SITE ANALYSIS

TAB NO.4

MASTER PLAN NARRATIVE

URBAN DESIGN STANDARDS

EXHIBIT 4.2: NATURAL FEATURES & EXISTING CONDITIONS MAP

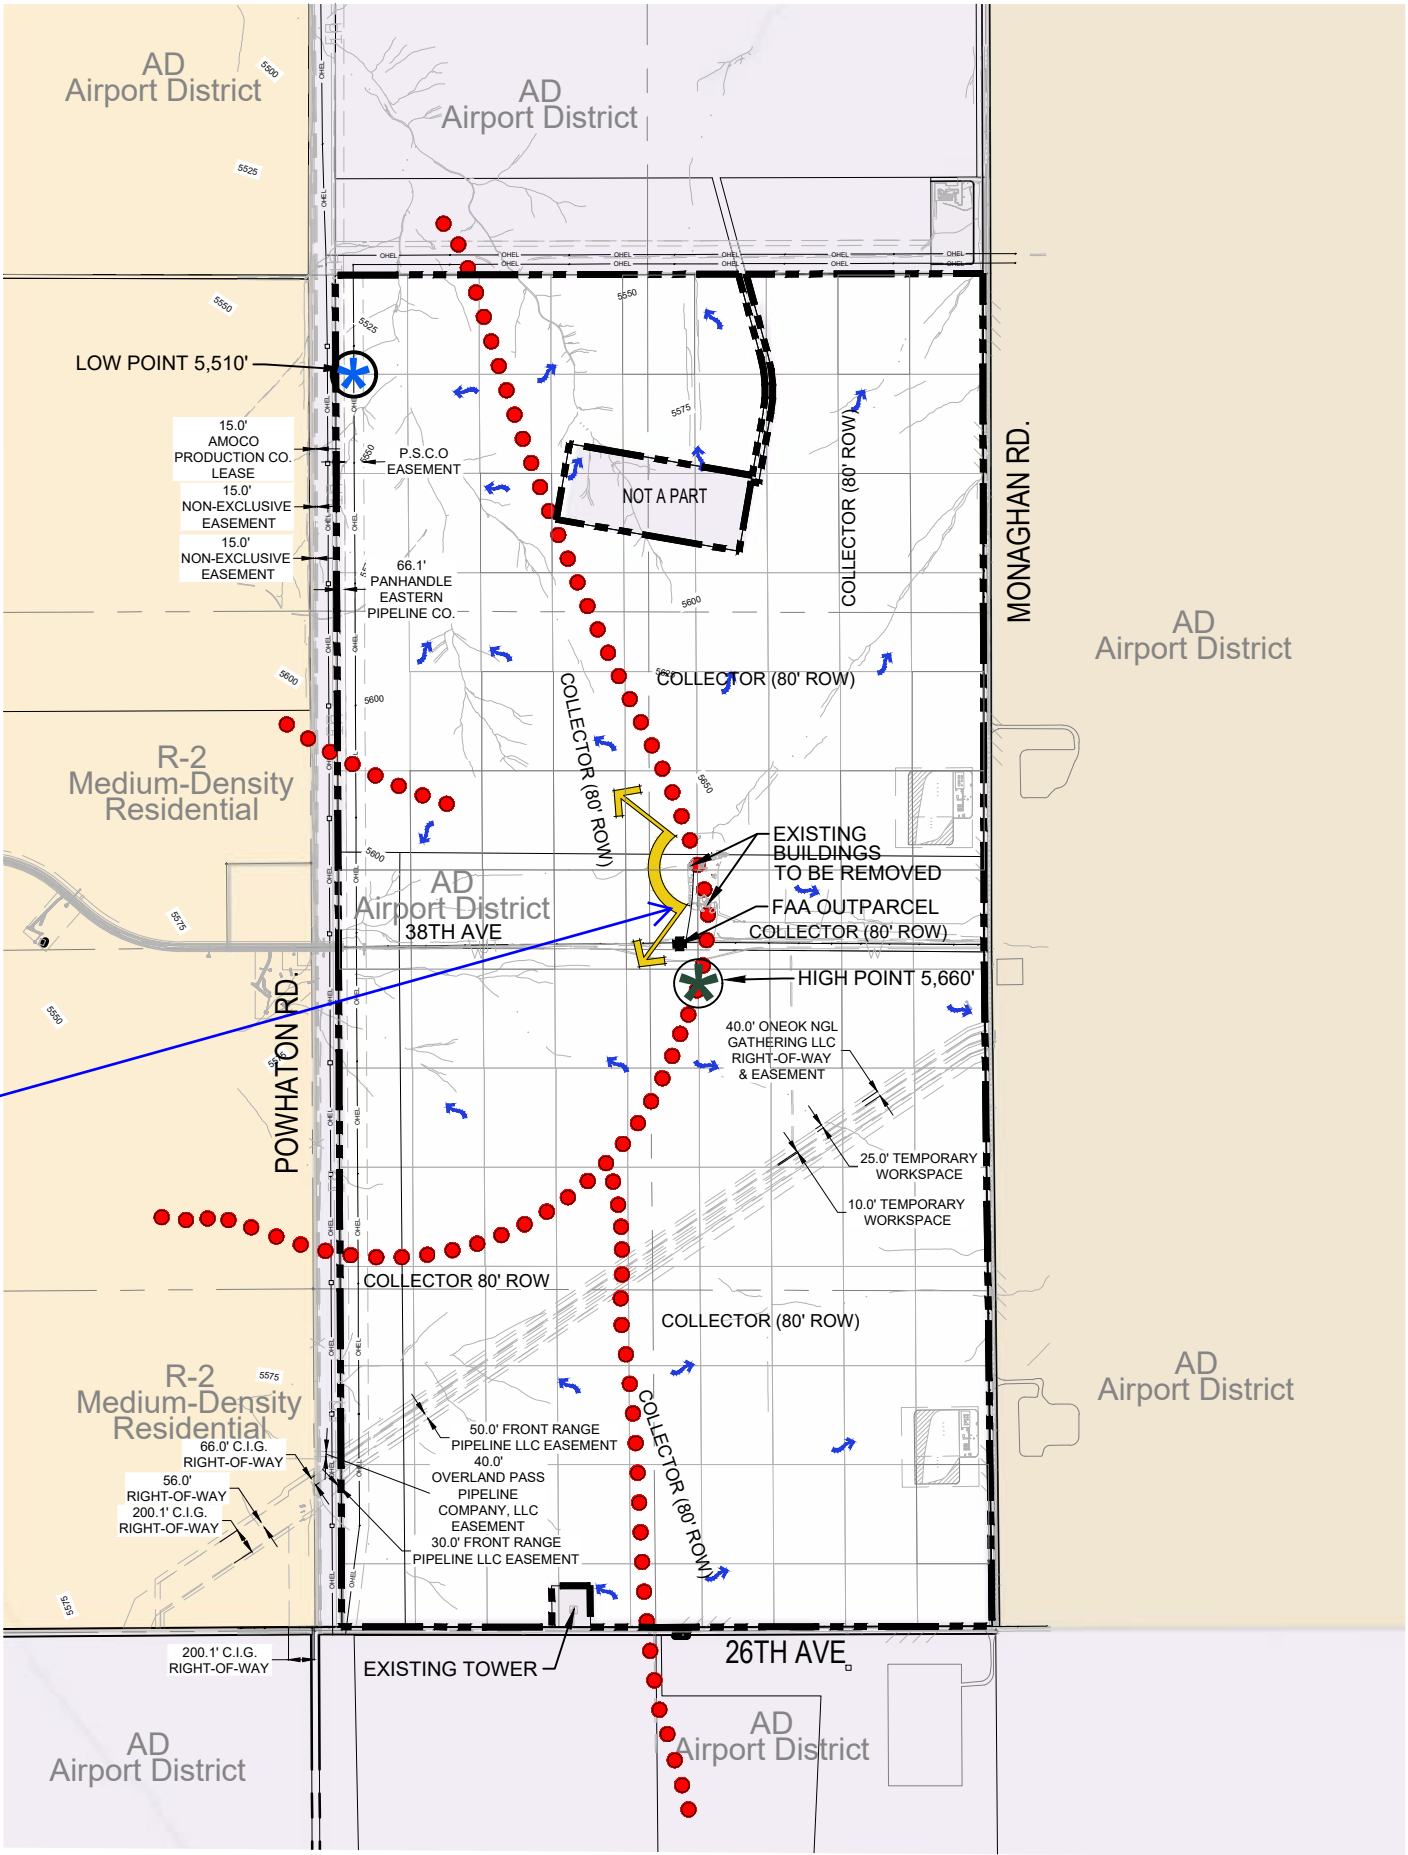
The existing farmhouse along E. 38th Avenue- is this structure historically significant at all? ADCO records date it from the early 20th century? Can any of it remain or be incorporated into the site? Please add some information about historical context of the farm.

Response: The farmhouse is in very poor condition and serves no historical significance. This building will be removed at time of development.

EXHIBIT 8.2: LAND USE MAP

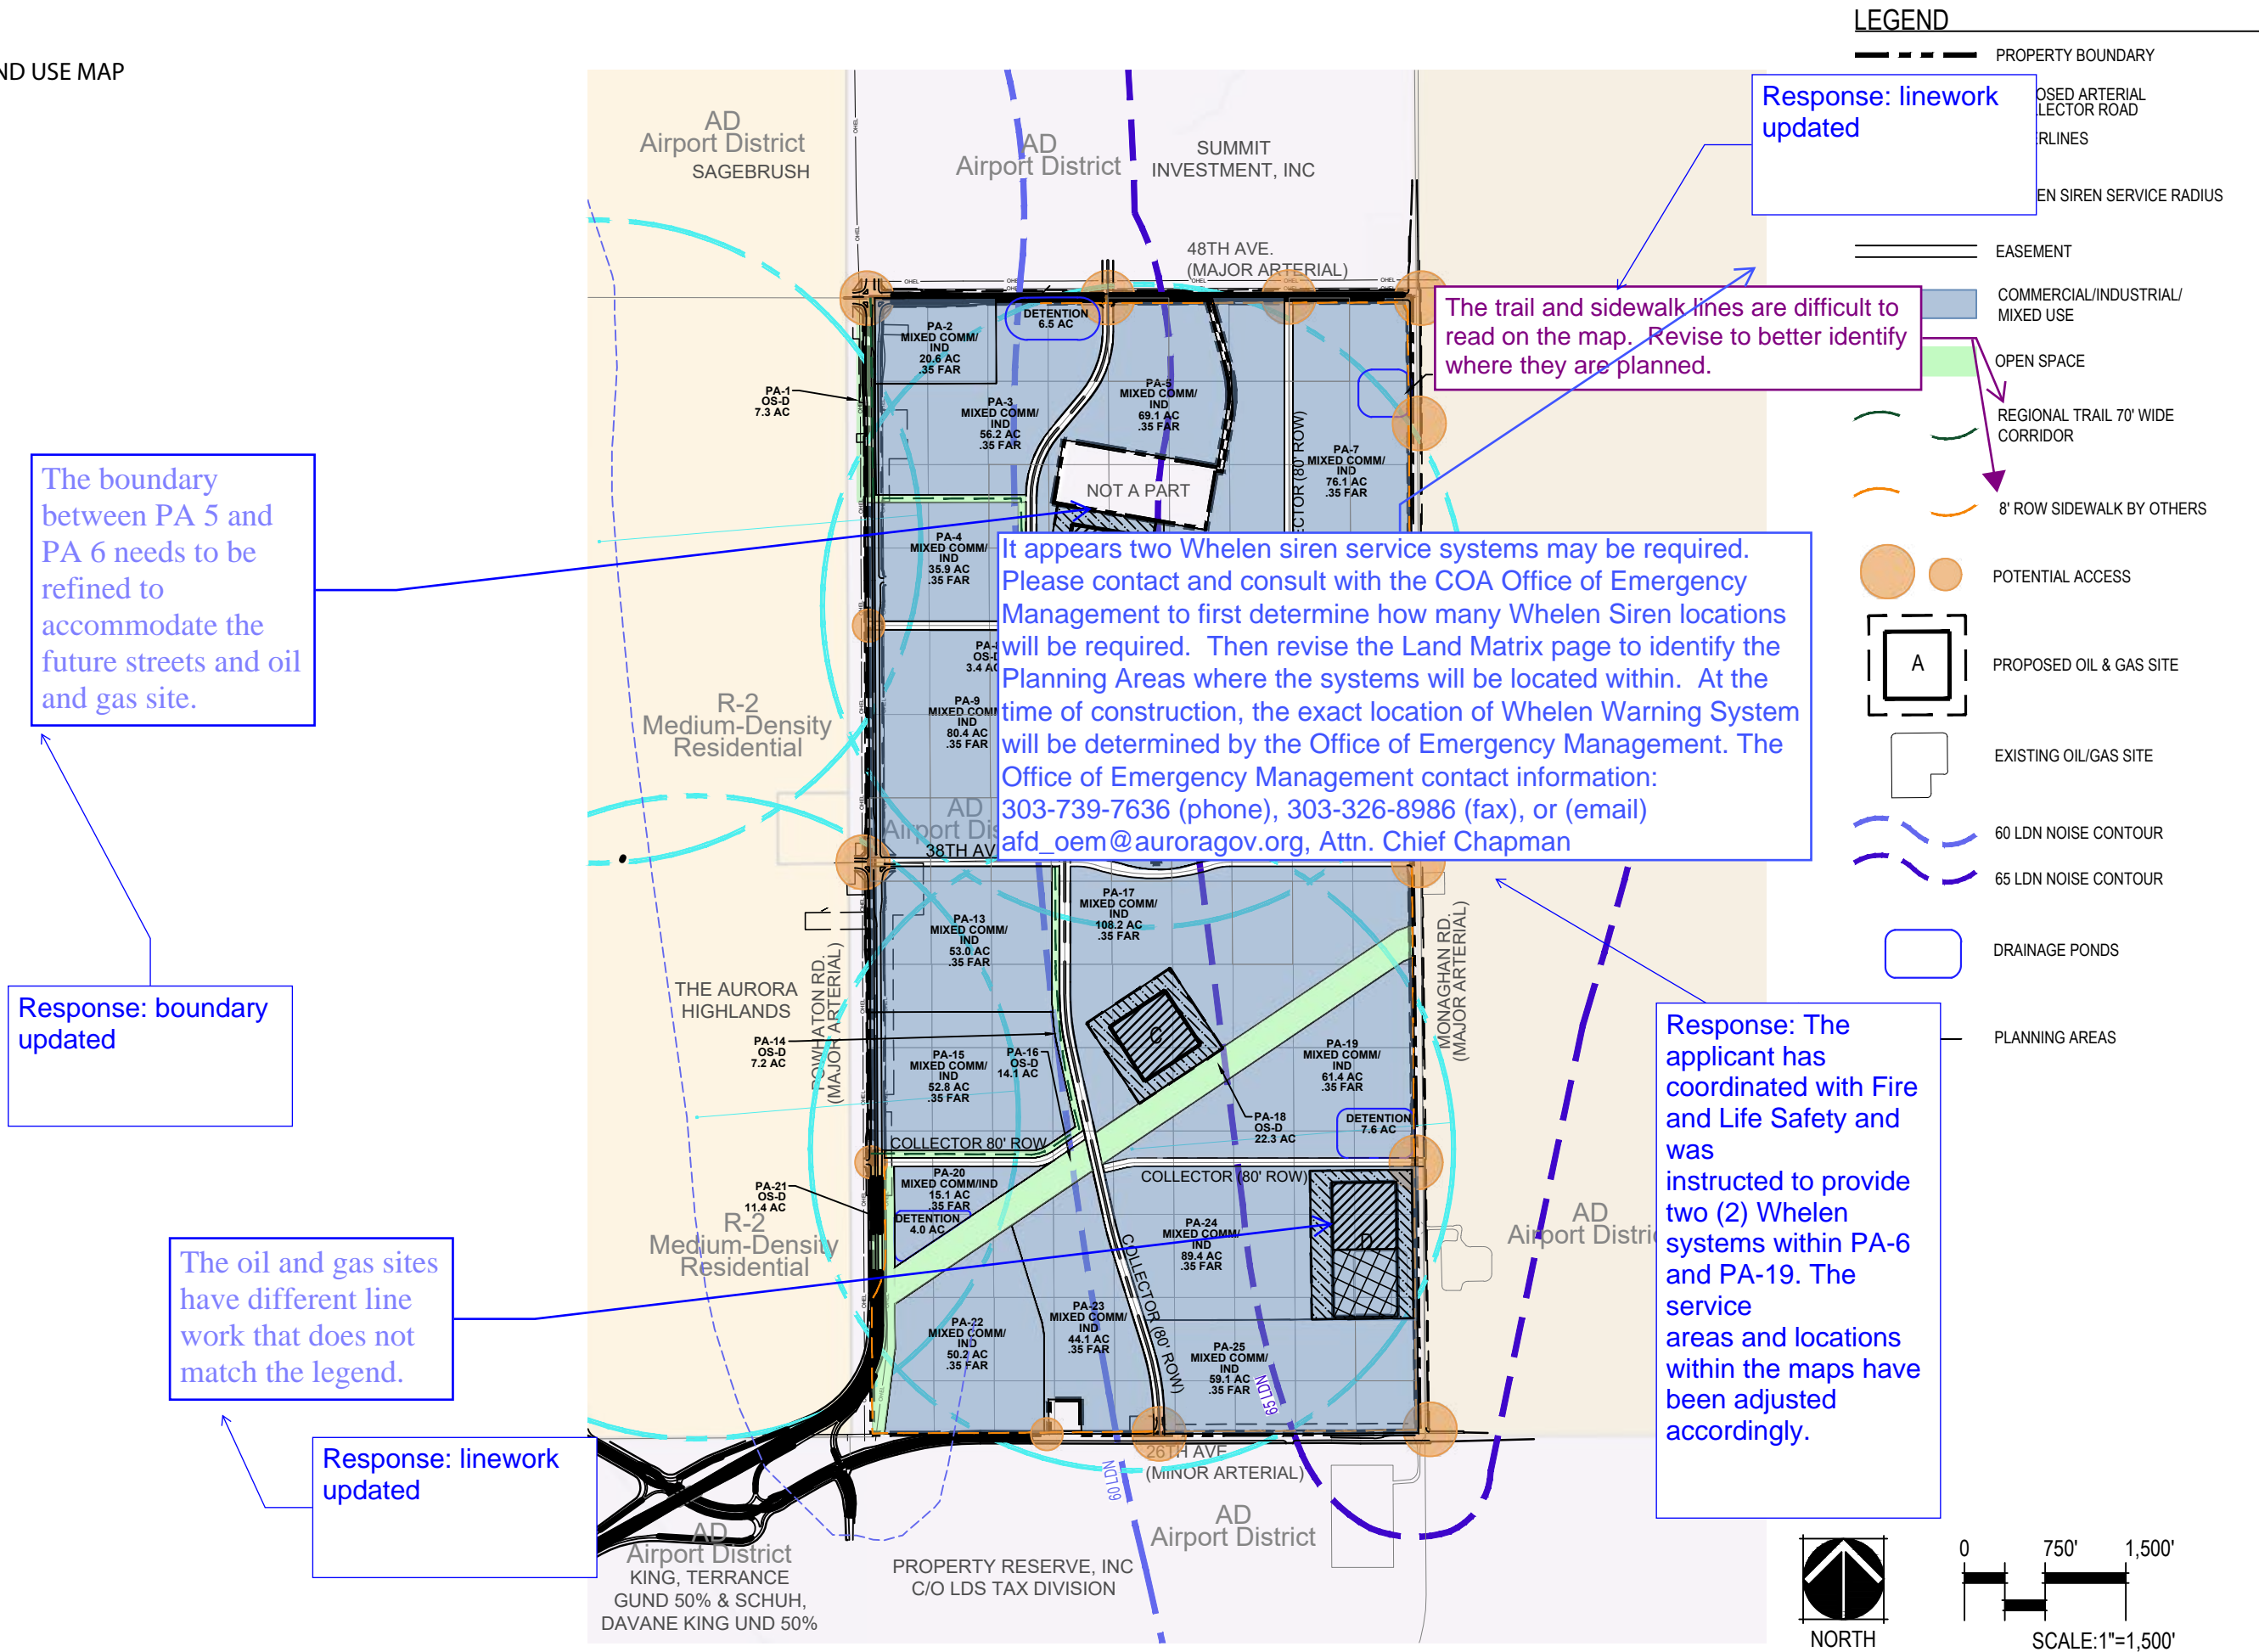
Section 2 on form D,
Whelen system,
needs to be revised
to reflect the
potential sites.
Please see Whelen
system comments
on the next sheet for
additional
information.

Response: The applicant has coordinated with Fire and Life Safety and was instructed to provide two (2) Whelen systems within PA-6 and PA-19. The service areas and locations within the maps have been adjusted accordingly.

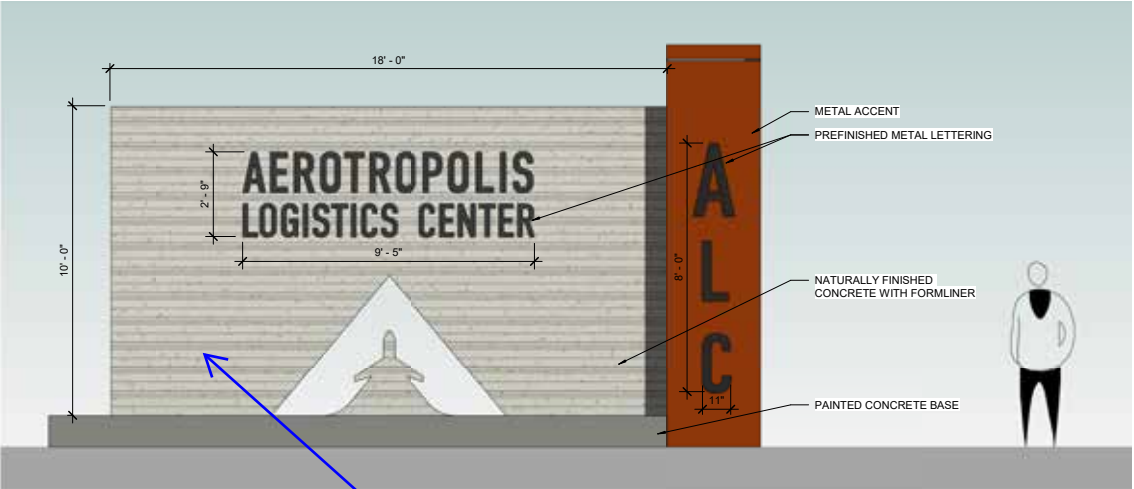
Uniform signage needed for business monumentation as well.

Page 13 explains that the font type will be present on all signs. Individual business will be allowed to incorporate their unique signage provided they stay

MONUMENTATION KEY MAP

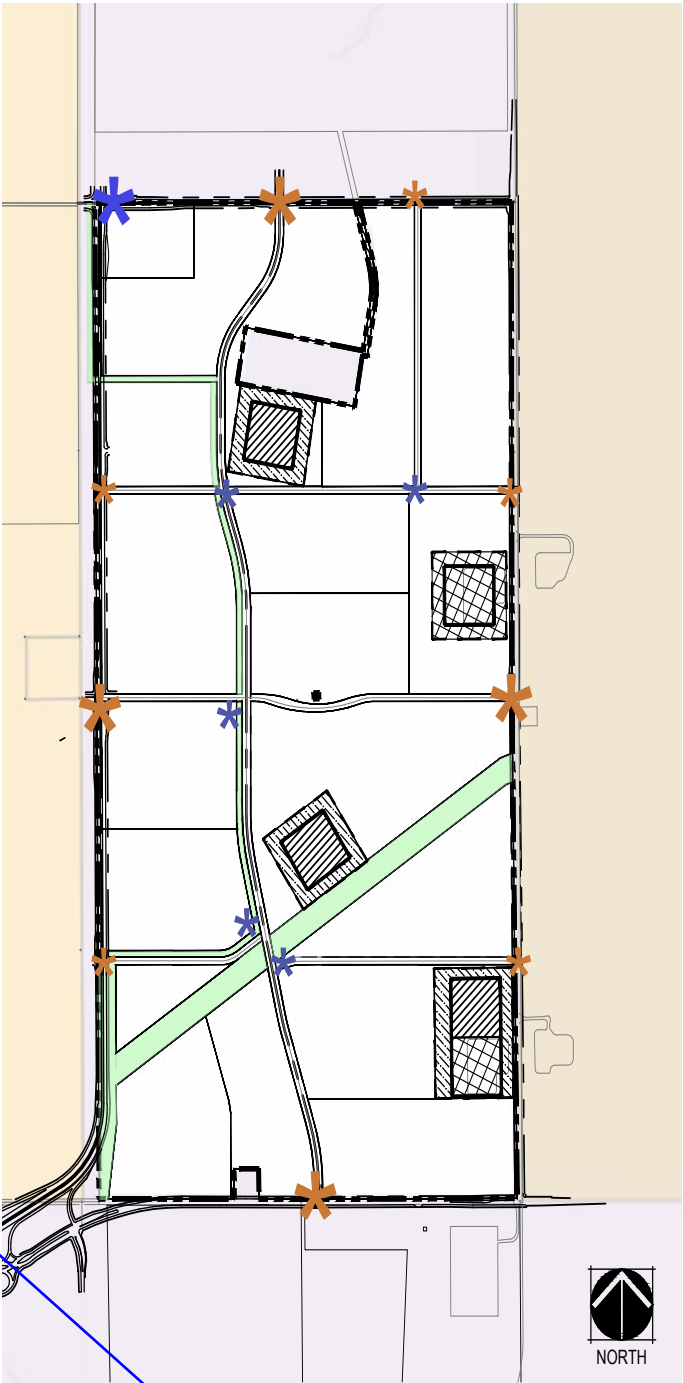
Add a detail for individual monument signage if proposed/allowed

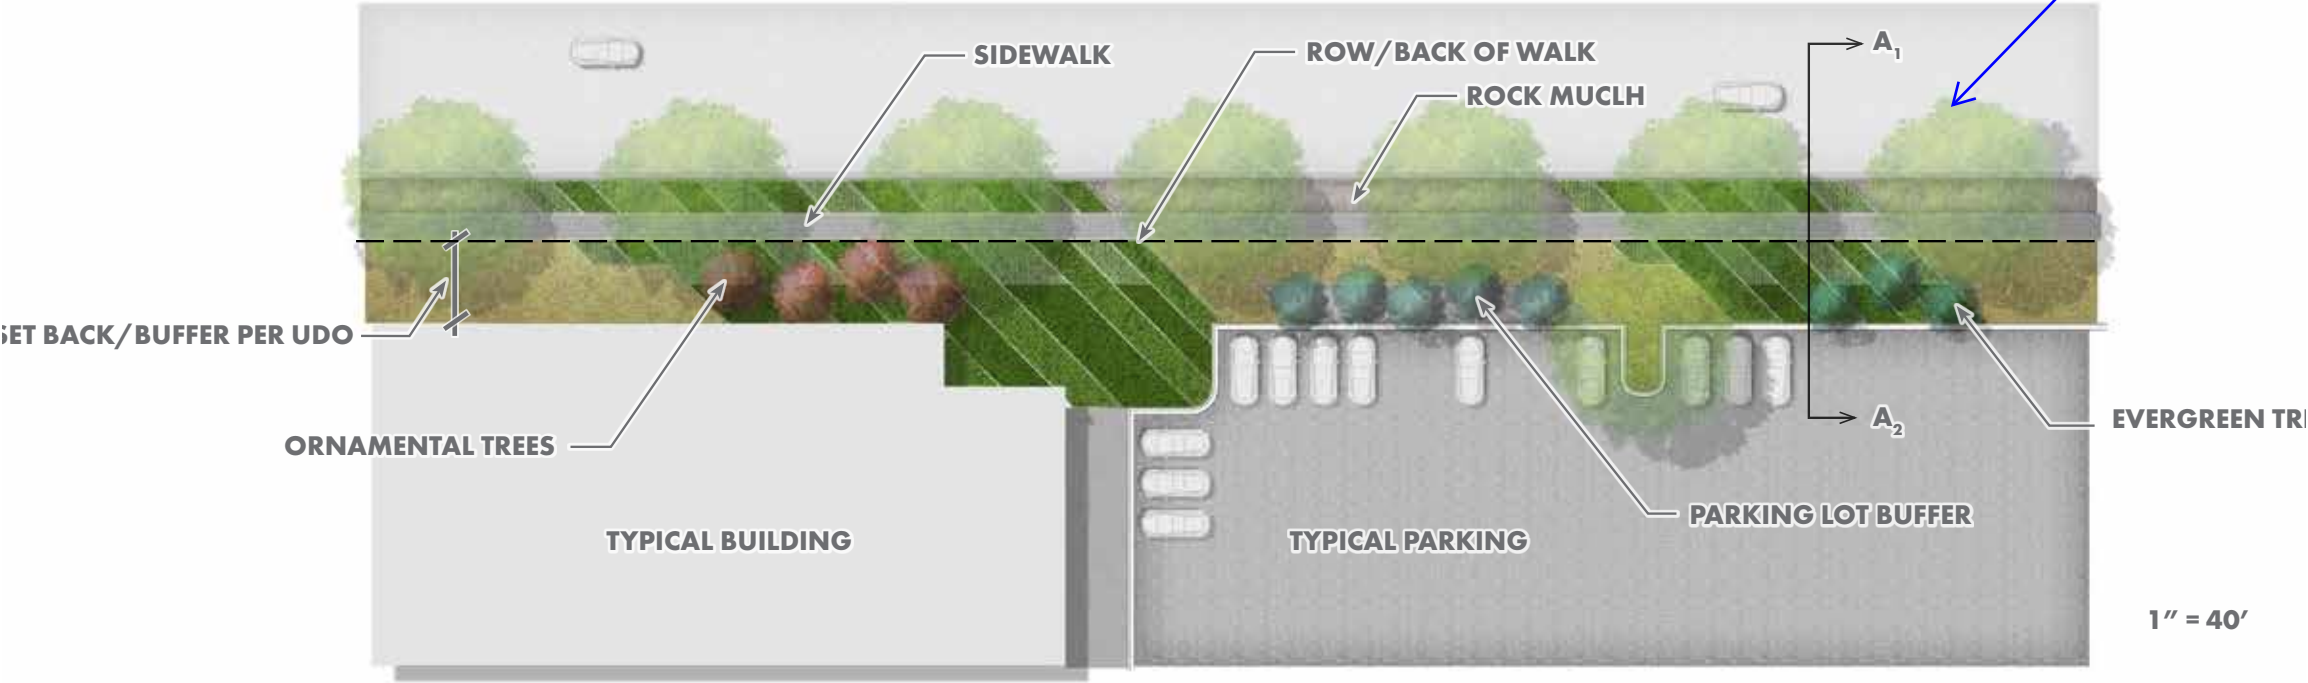
can we do low shrubs and low walls in addition to evergreen trees?

Don't want to generalize this as it might be an expected item on site plans. The main attempt here is to show how the ARTA ROW design would transition into an adjacent site.

TRAILS MASTER PLAN

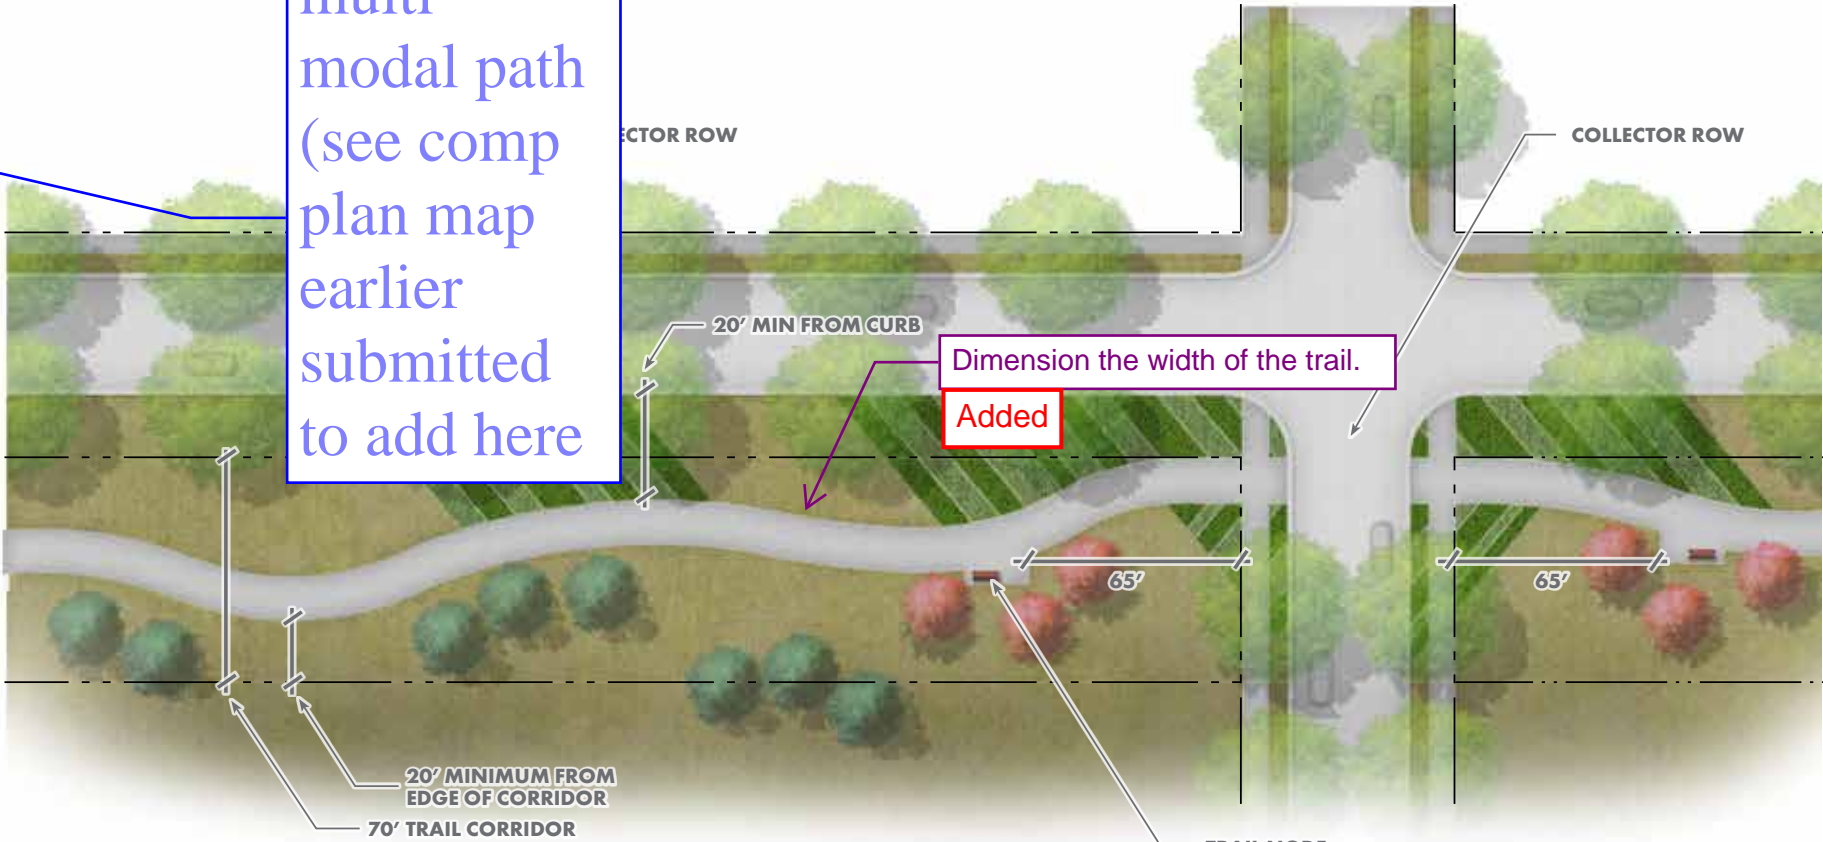
Include in the narrative the width of the trail to be constructed within the interior spine.
